MEMORANDUM

To: Justin Gibson, Fire Division Chief: Director of Fire Prevention & Support Services, Chula Vista Fire Department
From: Michael Huff, Principal Fire Protection Planner
Subject: **Village 3 Fire Protection Plan Addendum and Exhibit Updates**
Date: October 27, 2016
Attachment(s): Revised Fire Protection Plan Figure nos. 8, 10, 11, and 12

Z:\projects\66101\MAPS\FIRE\VILLAGE3\Revision_Marzo2014\Figure8_BehavePlusModeling.mxd

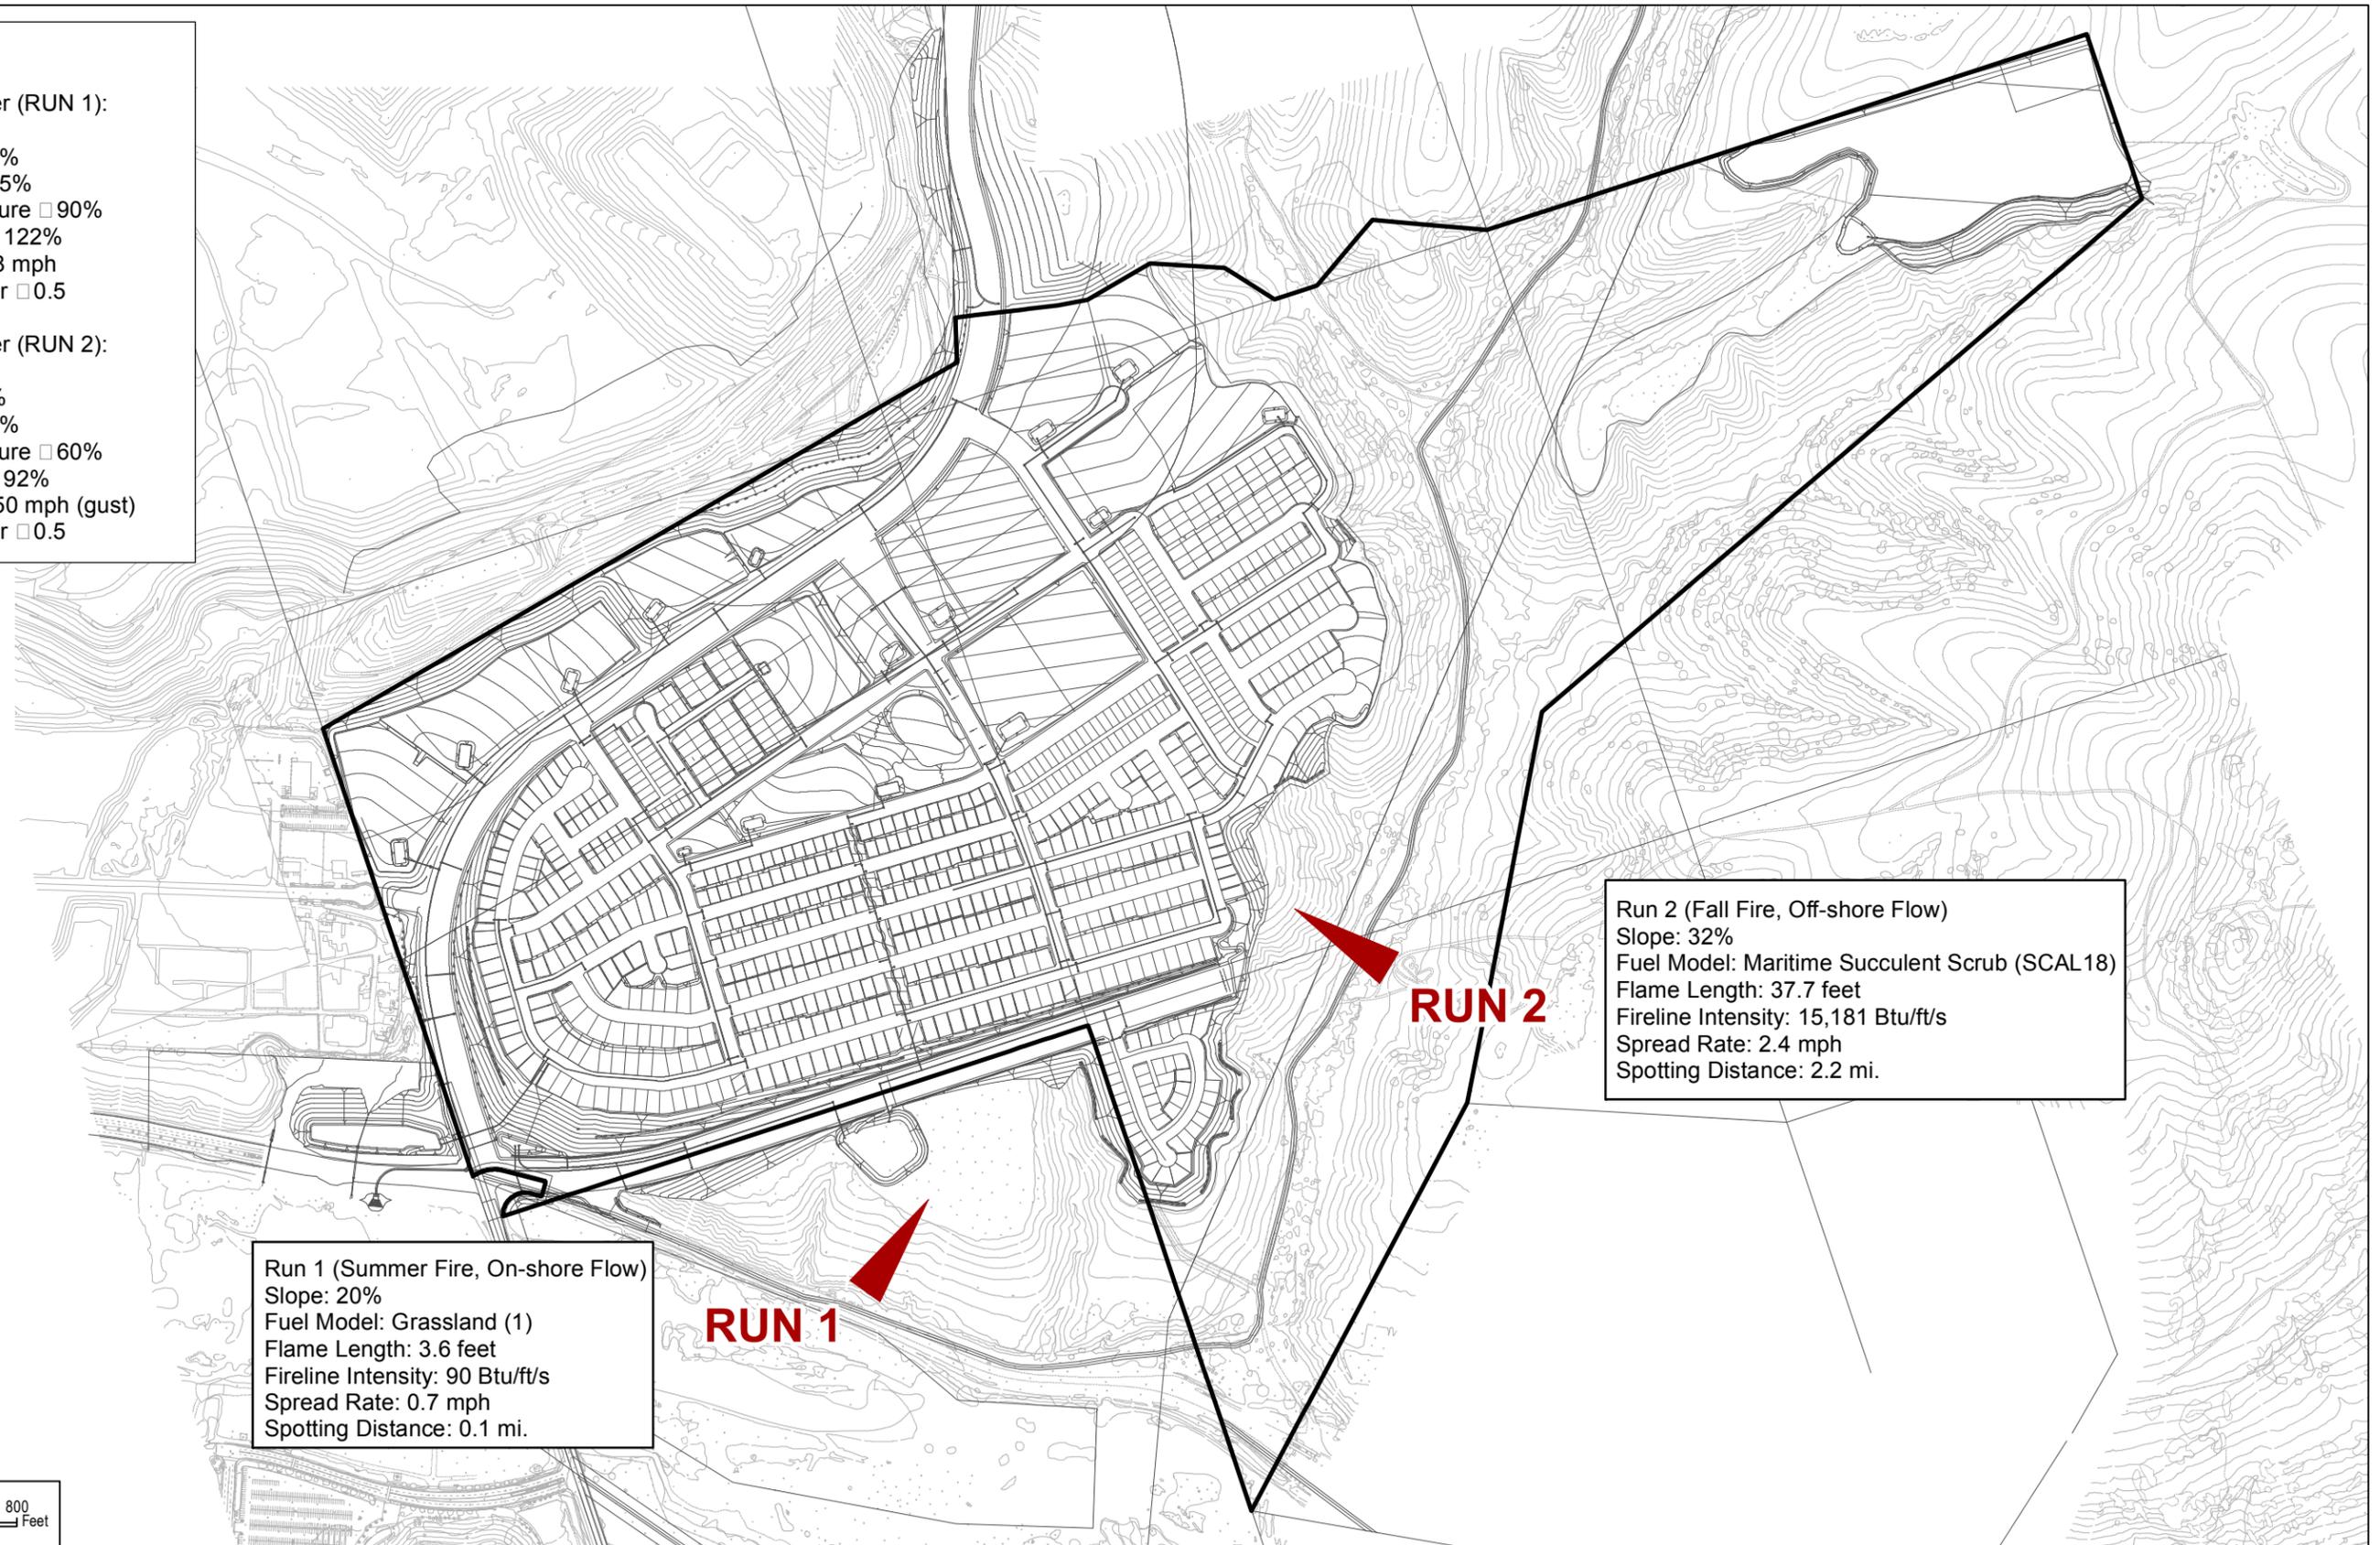
Item 1. Dudek has evaluated the revised site plan for University Villages, Village 3 and determined that the findings of the approved Fire Protection Plan (FPP) dated December 2014 remain applicable and valid. The site changes do not impact the analysis or results of the FPP. To that end, four figures, numbers 8, 10, 11 and 12, have been updated to reflect the new site plan and are attached for review.
